CITY OF SANTA ANA

TENANT IMPROVEMENT PLAN CHECK COMMENTS

PLAN CHECK NO:	10173563		
PROJECT ADDRESS:	3316 S Bristol St		
PLAN CHECK ENGINEER:	Ahangian, Kathy	TEL: 714	647-5812
		FAX: 714	647-5897
TYPE OF CONSTRUCTION:	V B		
OCCUPANCY CLASSIFICATION(S):	B		
PLAN CHECK DATES:		REMARKS/RECHECK ITEMS:	
APPLICATION	10/27/2011		
INITIAL REVIEW	11/5/2011		
EXPIRATION	4/24/2012		
RECHECKS:	1. 12-28-2011	PROJECT APPLICANT CONTACT PERSON:	
	2.	Irfan Boukai	
	3.	TEL:	(949)701-4962
VALUATION:	\$60,000.00	FAX:	
FLOOD ZONE:	X-0602320259J	EMAIL:	irfanb@cox.net

PLAN NUMBER PAPA JOHN'S PIZZA

ENLARGED ACCESSABILITY DETAILS

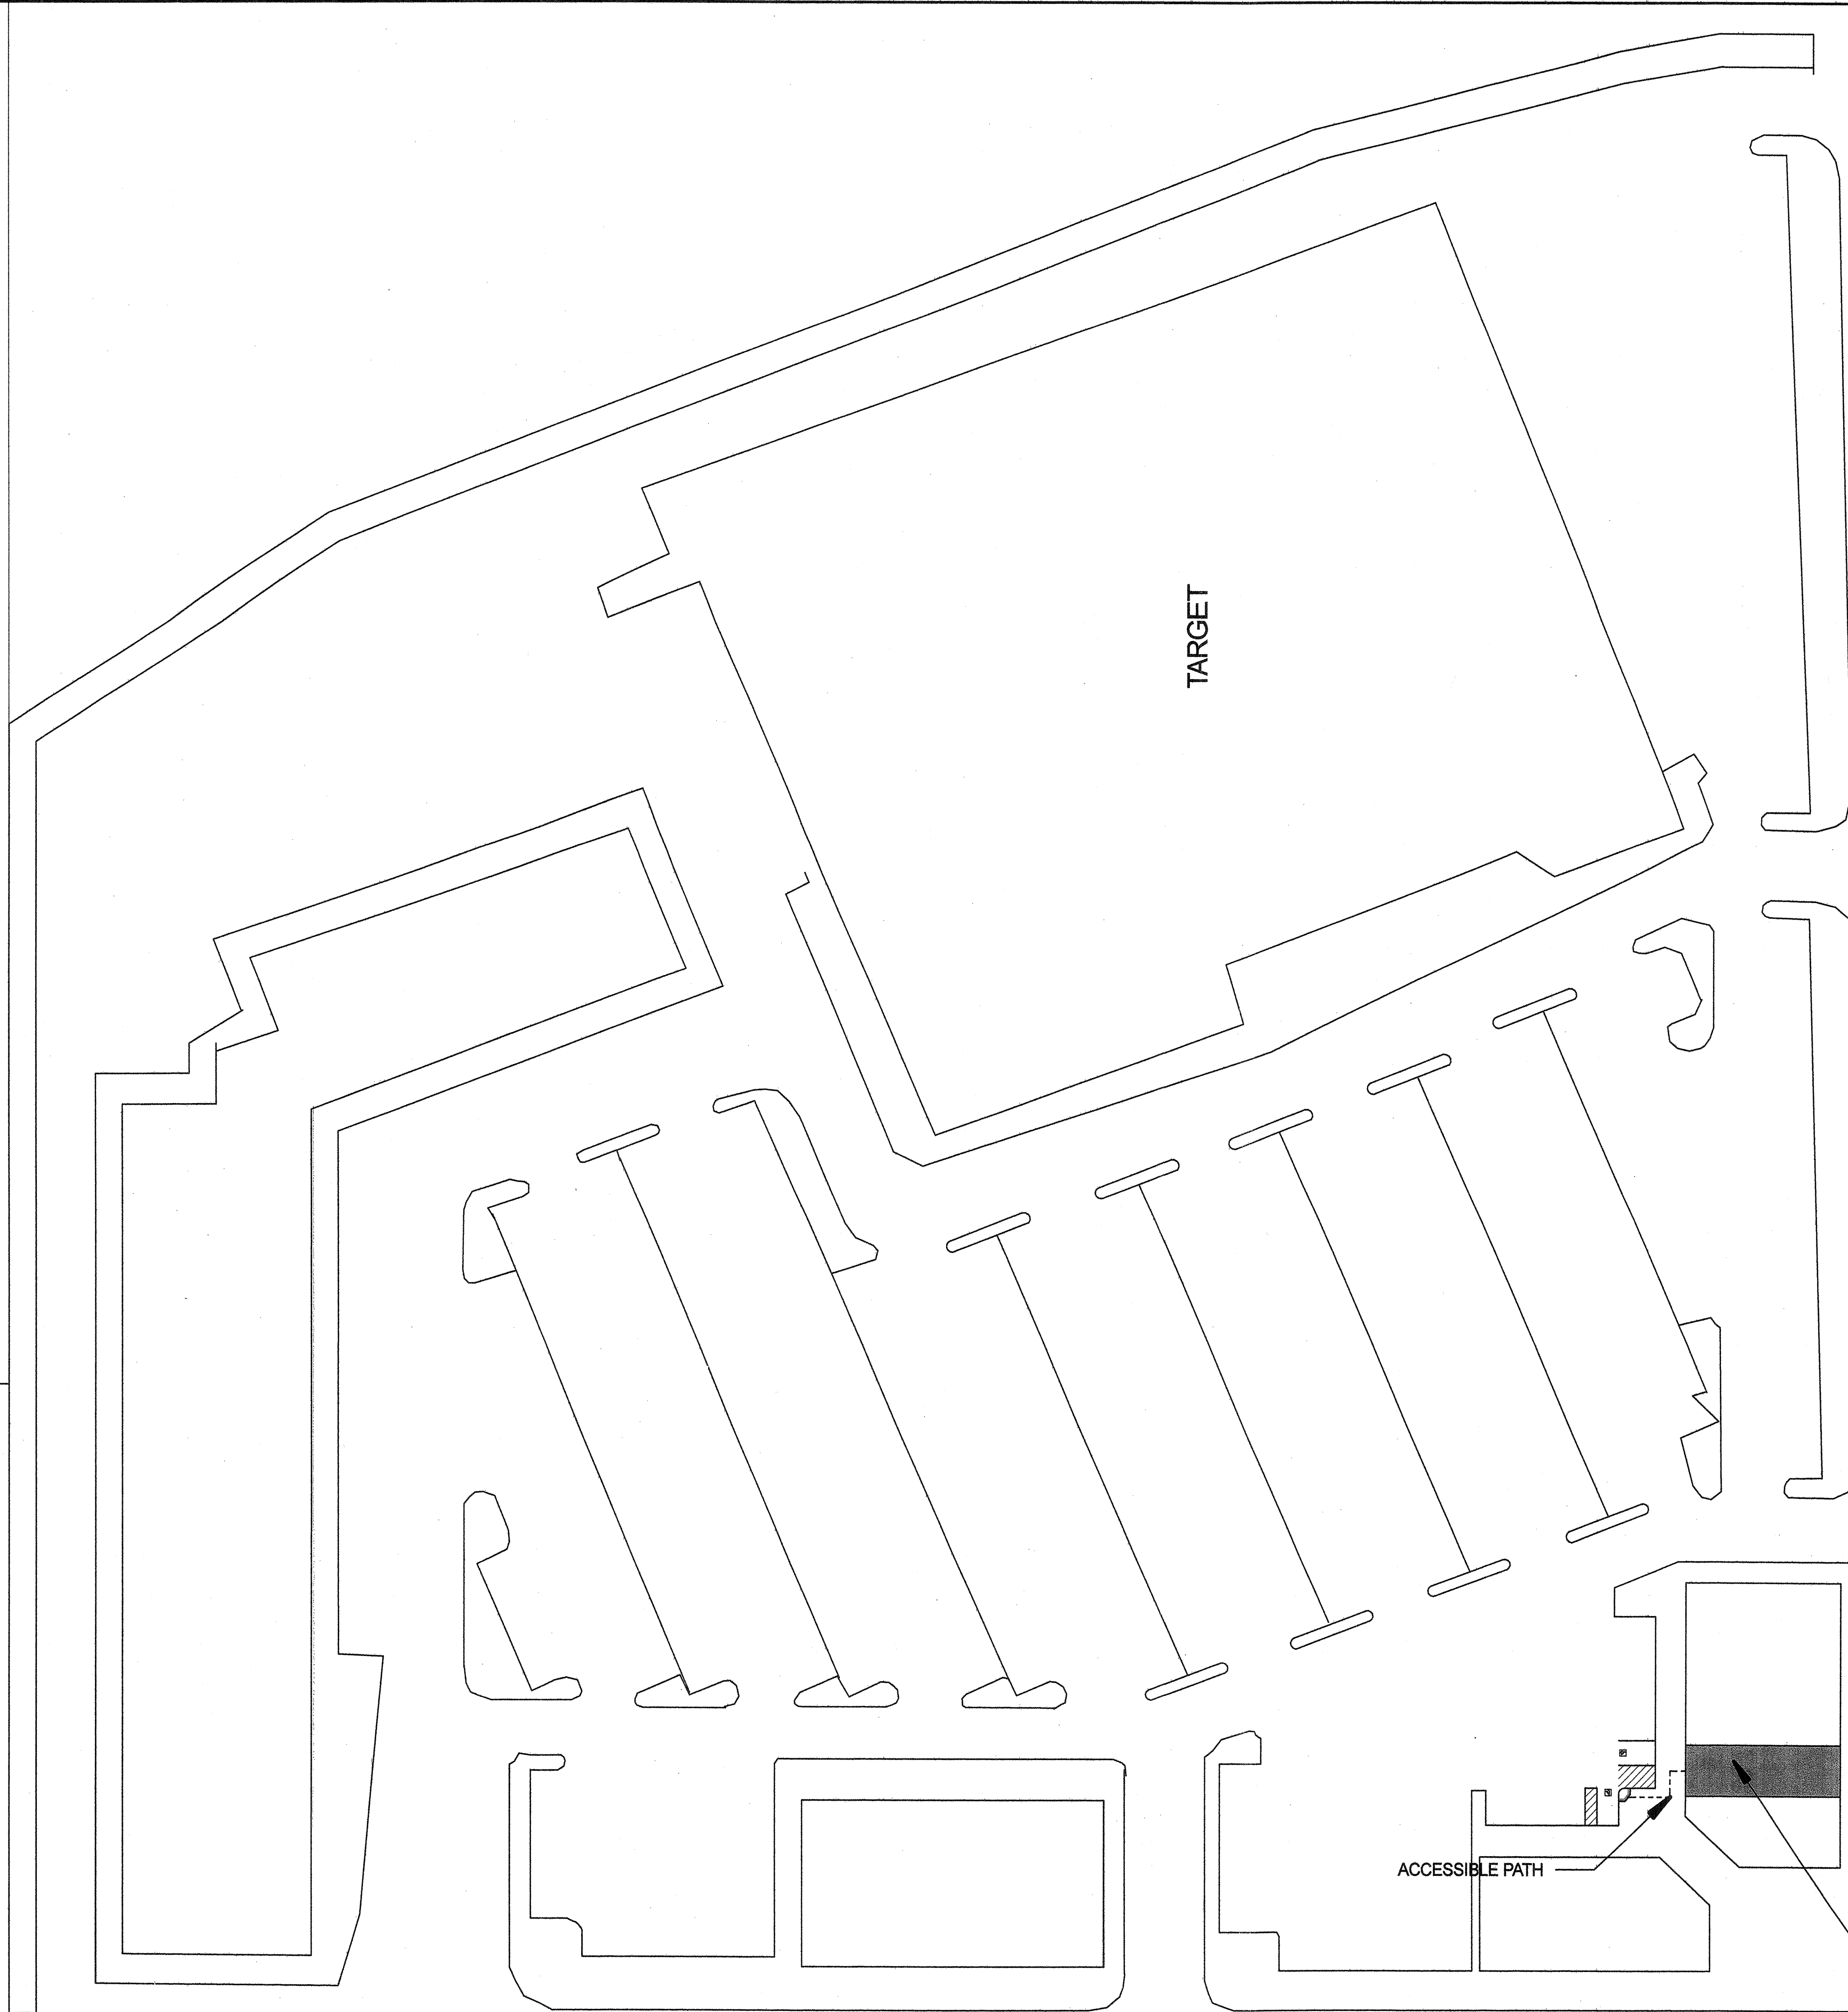
11. Enlarge handicap parking to show it is in compliance with path of travel. *12-28-11* **provide truncated dome on curb ramp for the full ENLARGED A-1 length and width of the ramp**

A-2

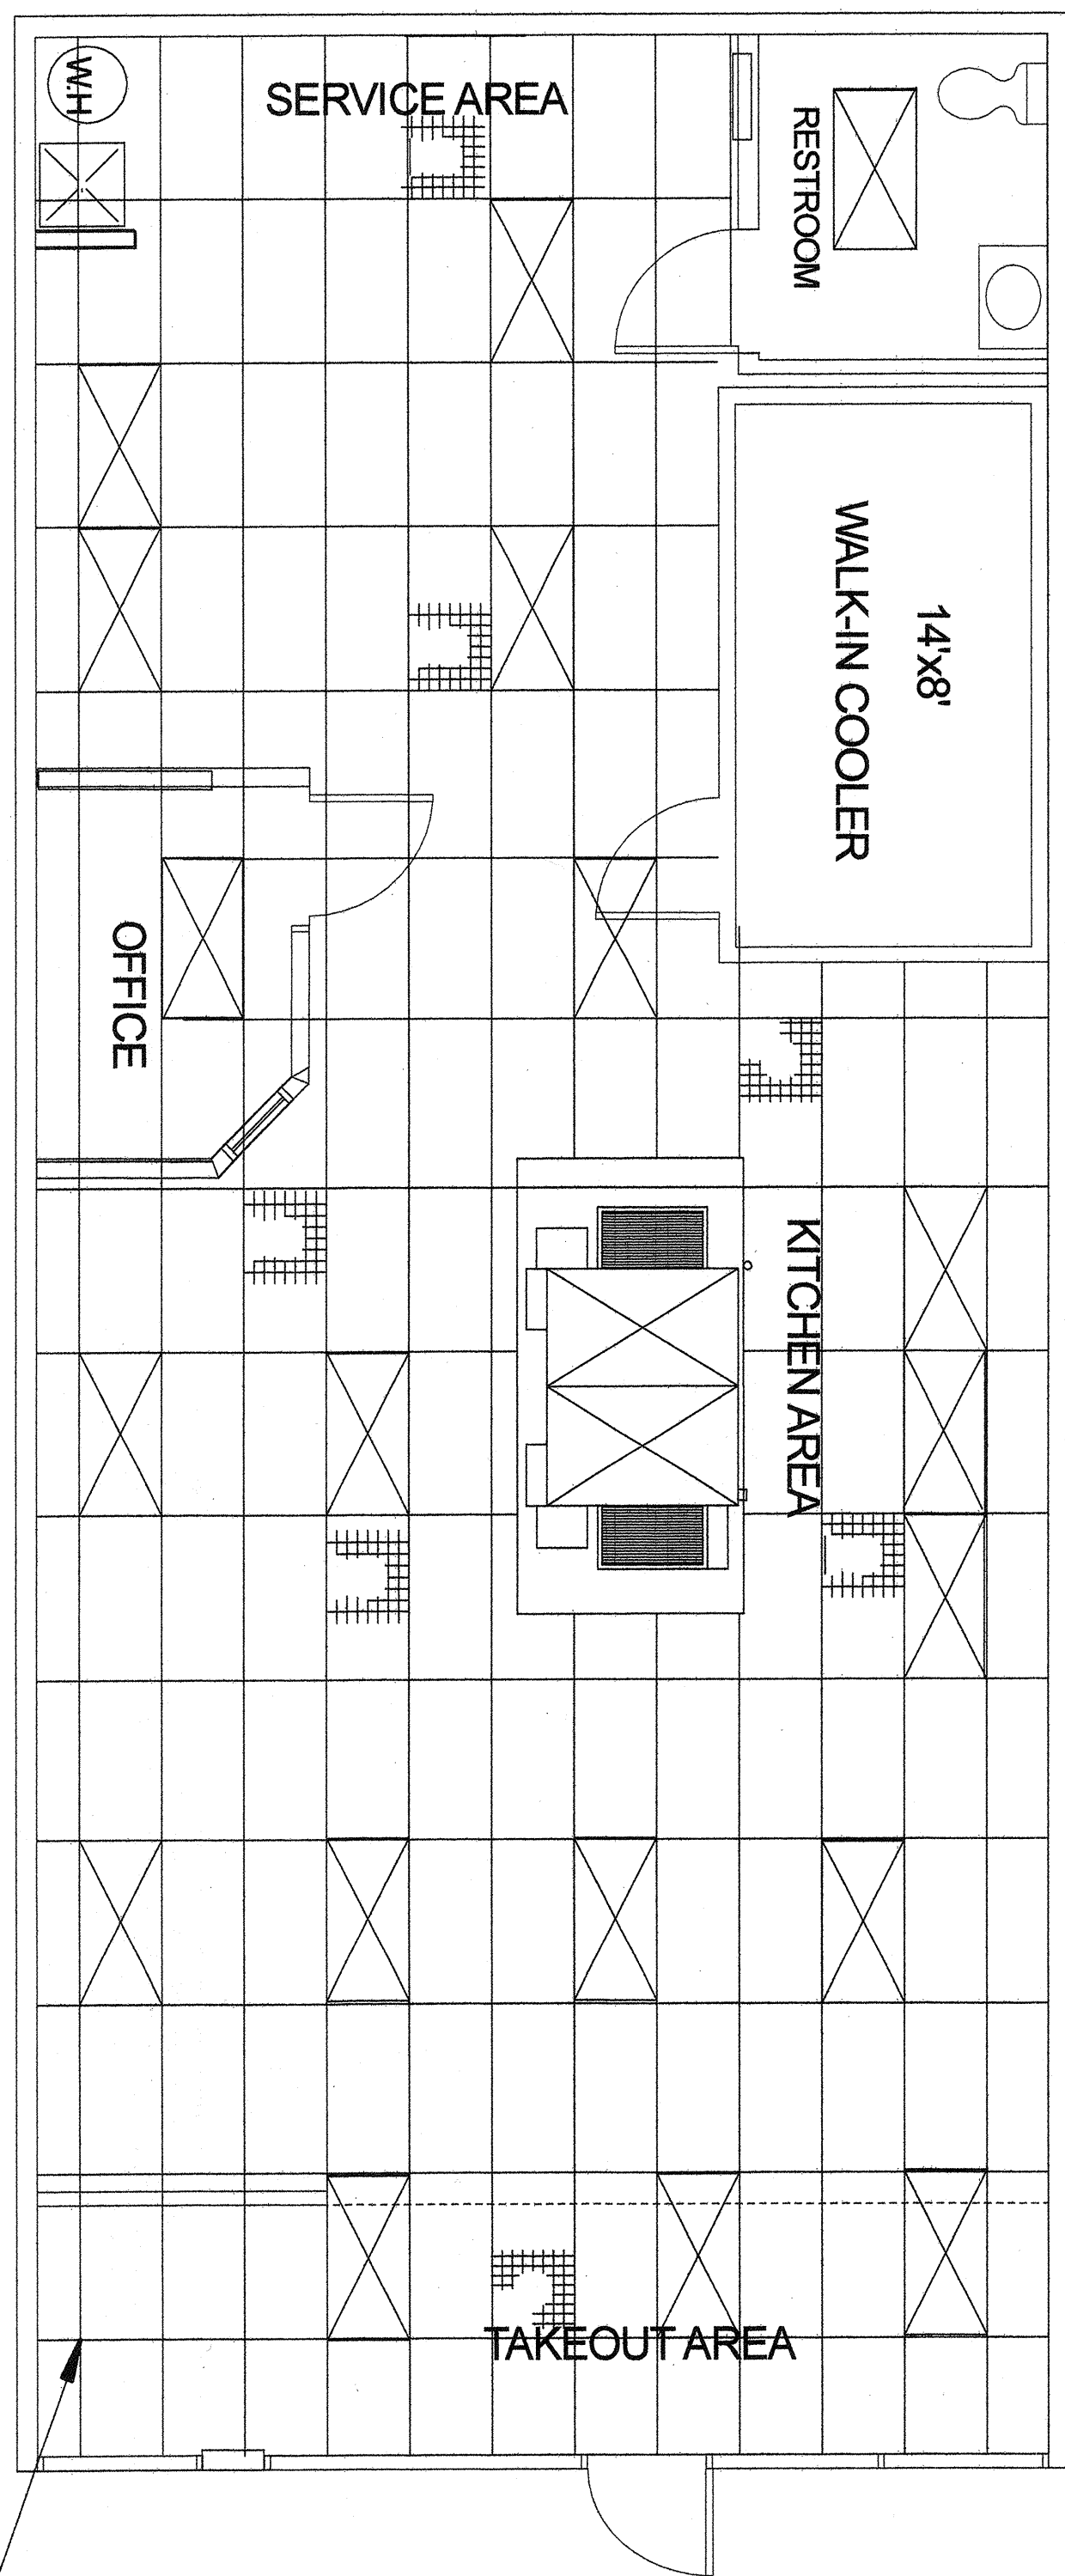
12. Provide minimum 30" x 48" clearance at the hand sink. *12-28-11* **A-2/A-5 ADDED**

13. Provide minimum 60" clear radius in the office. *12-28-11* **A-2/A-5 ADDED**

14. Provide a wall legend indicating whether the wall is: *12-28-11* **A-2**

15. Provide typical section view detail of all new partitions and ceilings showing: *Pending 12-28-11* **Height of the partition walls.** **A-2 / A-2**

HANGING ANGLE DETAIL

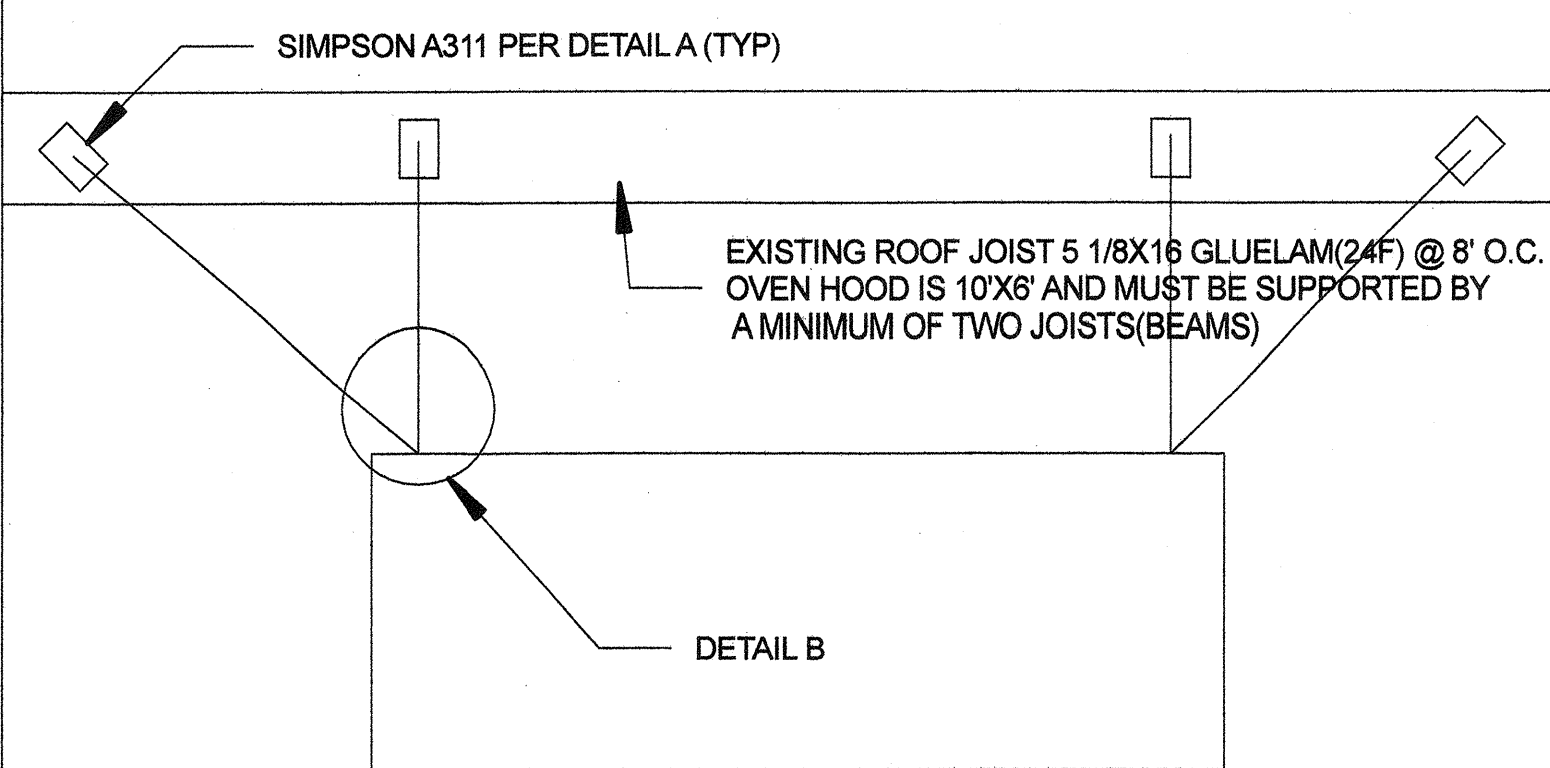
30) show size of the roof joists on sheet A3 (Detail for hood attachment)

31) on hood attachment detail show size and spacing of the roof joists. (show how many roof joists are supporting the unit).

* add size of the oven hood.
Note, oven hood is being supported by 2 ^{min} Beam.

OVEN HOOD (449 LBS)

WATER HEATER SEISMIC RESTRAINT

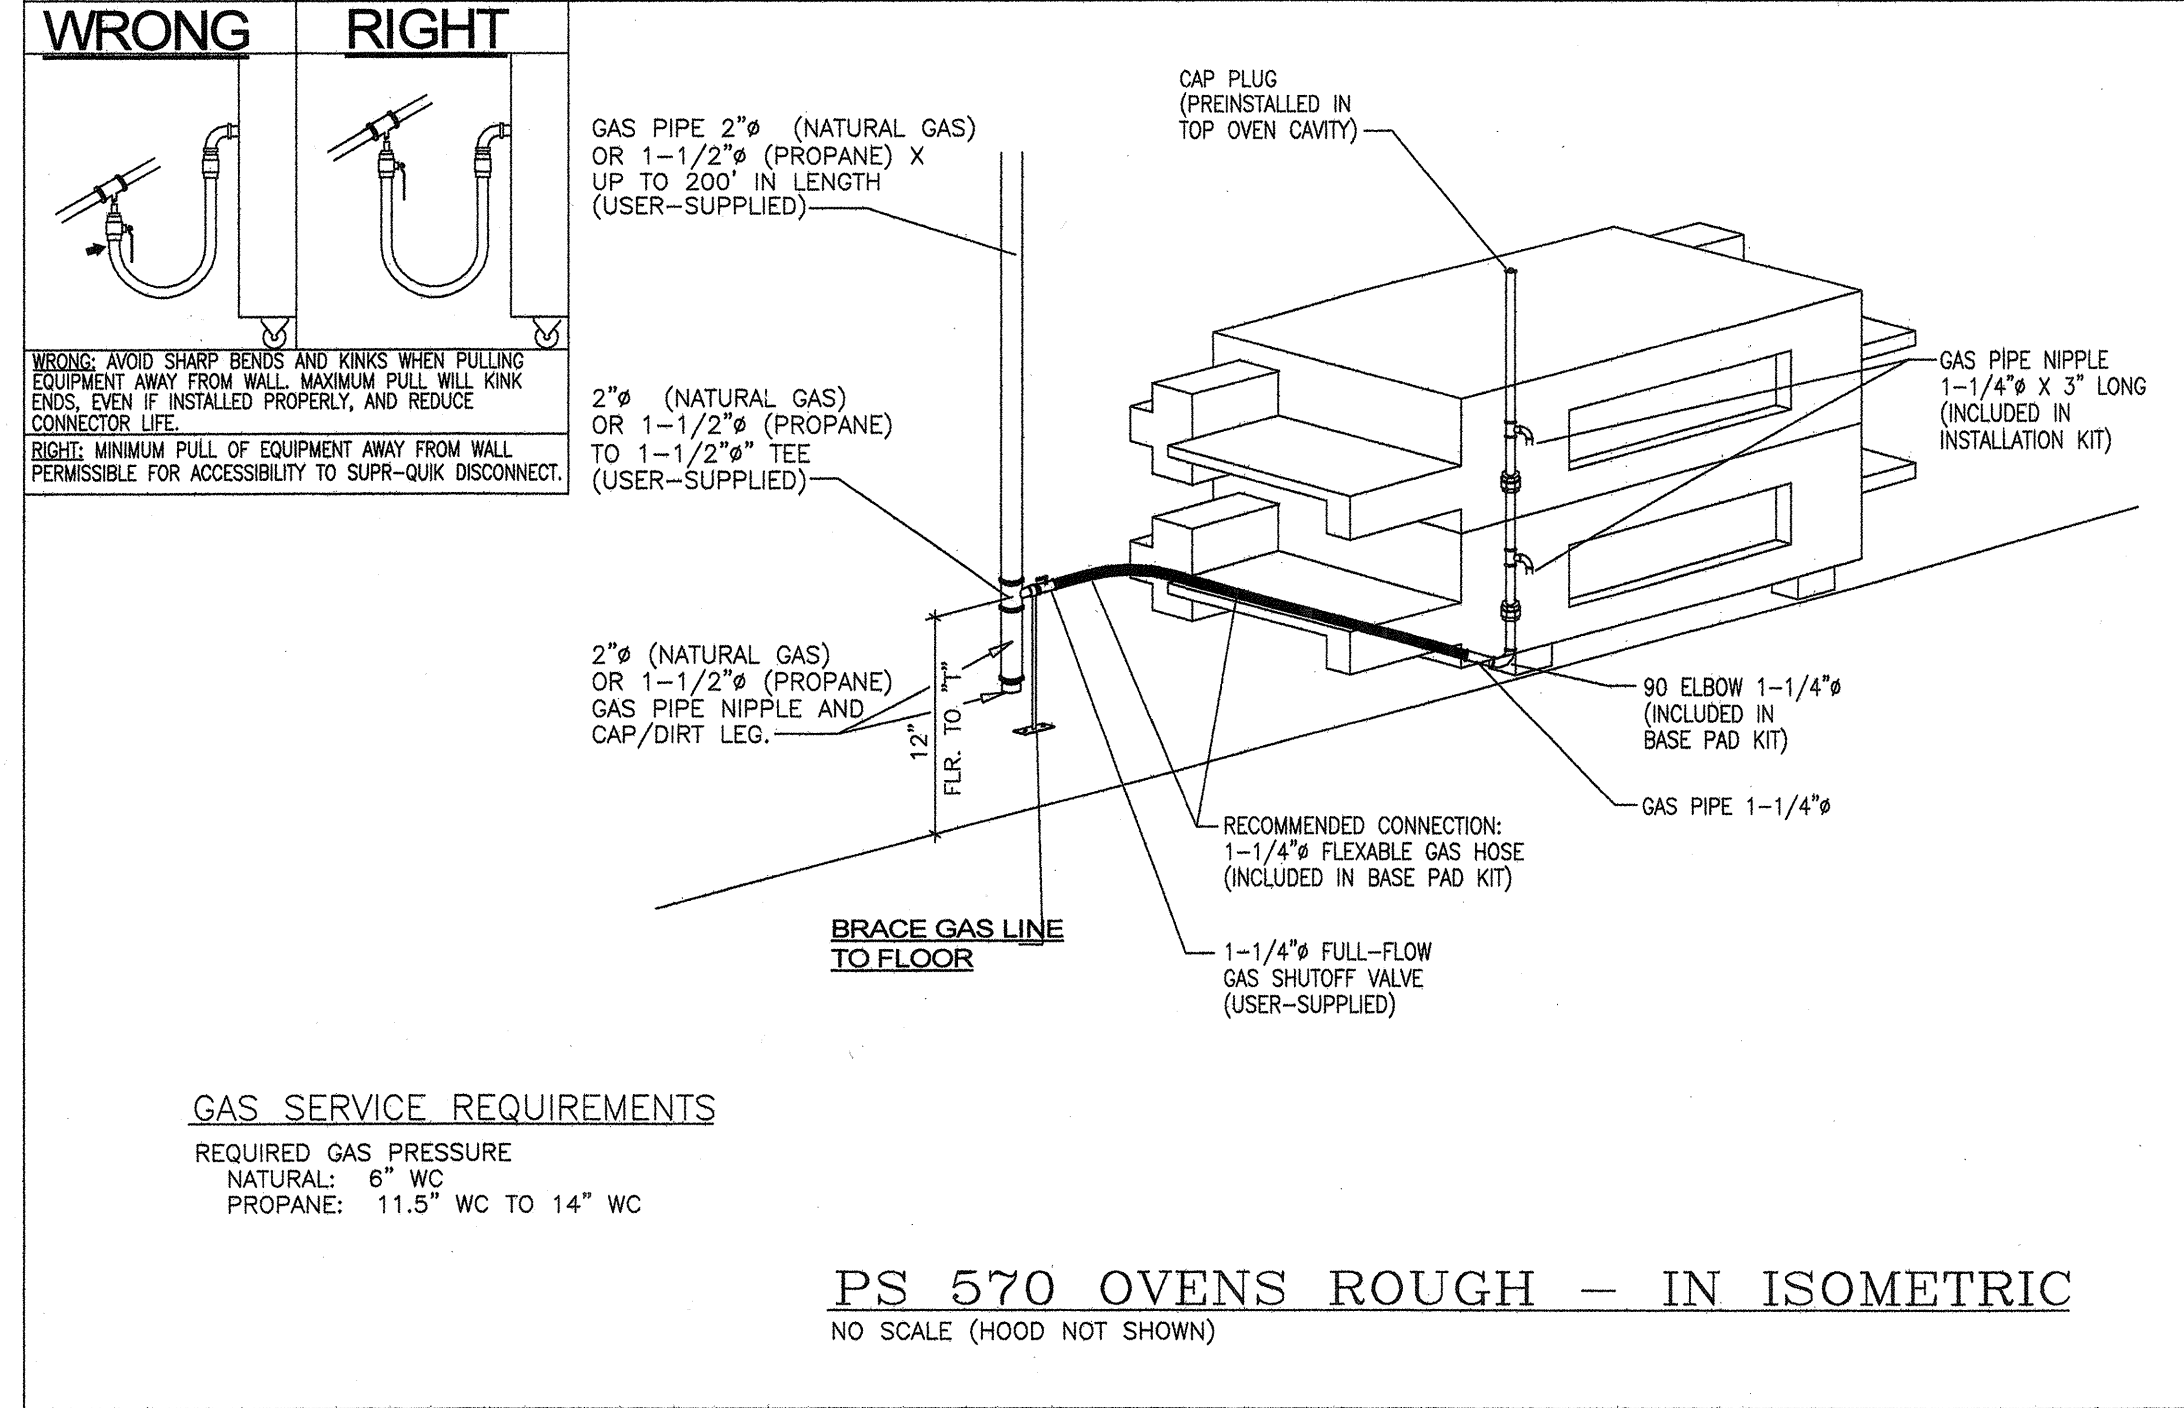
24. Provide details on the drawings for the seismic restraint of water heater.
